**CITY PLAN COMMISSION****THURSDAY, NOVEMBER 7, 2024****FILE NUMBER:** S245-002**SENIOR PLANNER:** Hema Sharma**LOCATION:** between Winfield Avenue and Boone Avenue, northline of Merrifield Avenue**DATE FILED:** October 9, 2024**ZONING:** MF-2(A)**CITY COUNCIL DISTRICT:** 2**SIZE OF REQUEST:** 0.7488-acres**APPLICANT/OWNER:** General Housing Partners, LLC; 1742 Samuel LP**REQUEST:** An application to replat a 0.7488-acre tract of land containing all of Lots 8 through 11 in City Block F/2663 to create one lot on property located between Winfield Avenue and Boone Avenue, northline of Merrifield Avenue.**SUBDIVISION HISTORY:**

**PRELIMINARY PLAT**  
**BEEMAN ESTATES**  
**LOT 8A, BLOCK F/2683**  
**BENING A REPLAT OF LOTS 8-11,**  
**BLOCK 2883, INTERCHANGE HIGHWAY 20,**  
**BOONE AVENUE, WINDROSE,**  
**THOMAS LAGOON SURVING, ABSTRACT 799**  
**CITY OF DALLAS DALLAS COUNTY, TEXAS**

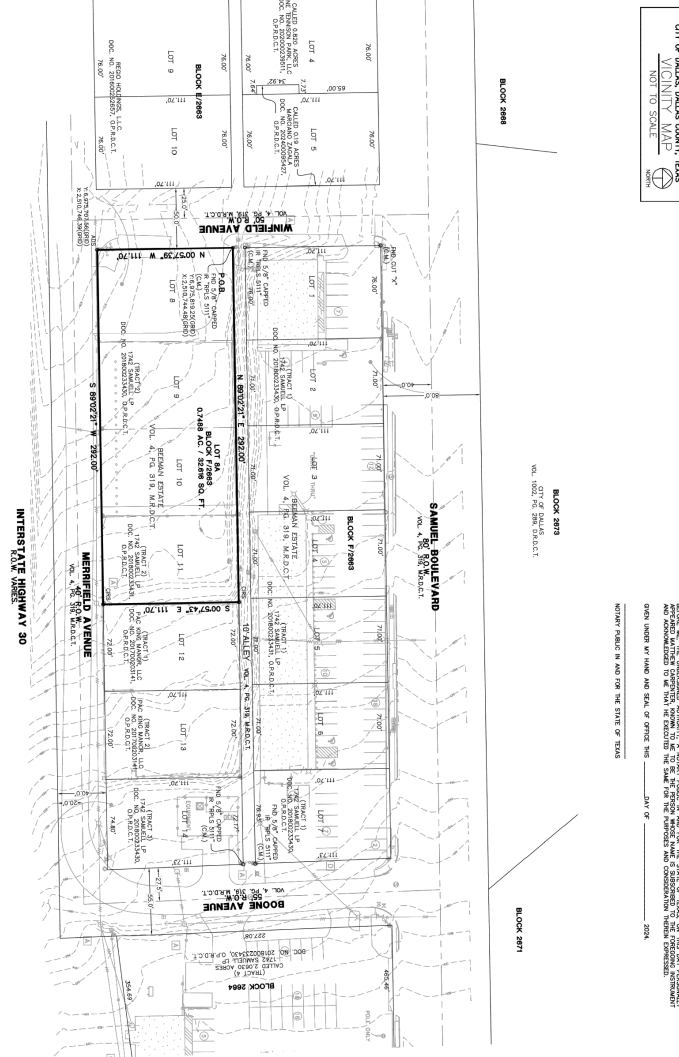
15. On the final plat, dedicate 7.5 feet of right-of-way (via fee simple) from the established center line of Alley. *Section 51A 8.602(c)*
16. On the final plat, dedicate 28 feet of right-of-way (via fee simple or street easement) from the established centerline of Merrifield Avenue. *Sections 51A-8.602(c), 51A-8.604(c) and 51A-8.611(c).*

17. On the final plat, dedicate 28 feet of right-of-way (via fee simple or street easement) from the established centerline of Winfield Avenue. *Sections 51A-8.602(c), 51A-8.604(c) and 51A-8.611(c).*

18. On the final plat, dedicate a minimum 5-foot by 5-foot corner clip (via fee simple or street easement) at the intersection of Merrifield Avenue & Winfield Avenue. Section 51A 8.602(d)(1)

19. On the final plat, dedicate a 15-foot by 15-foot Alley Sight Easement at the intersection of Winfield Avenue & the alley. *Section 51A-8.602(e)*
20. On the final plat, add the note: "TxDOT approval may be required for any driveway modification or new access point(s)."

22. Prior to final plat, submit a completed final plat checklist and all supporting documents.
23. On the final plat, show how all adjoining right-of-way was created. Section 51A-8.403(a)(1)(A)(xxii).

24. On the final plat, show recording information on all existing easements within 150 feet of the property.
25. On the final plat, show all additions or tracts of land within 150 feet of the property with recording information. Platting Guidelines.
26. On the final plat, chose a new or different plat name.

28. Prior to final plat, compliance with City's street lighting standards including illumination standards, material, installation, and activation per Street Design Manual.
29. On the final plat, change "Samuel Boulevard" to " Samuell Boulevard (FKA East Pike)" Section 51A-8.403(a)(1)(A)(xii).
30. On the final plat, change "Interstate Highway 30" to " R.L. Thornton Freeway / Interstate Highway No. 30 (FKA Roscoe Street)" Section 51A-8.403(a)(1)(A)(xii).
31. On the final plat, identify the property as Lot 8A in City Block F/2663.
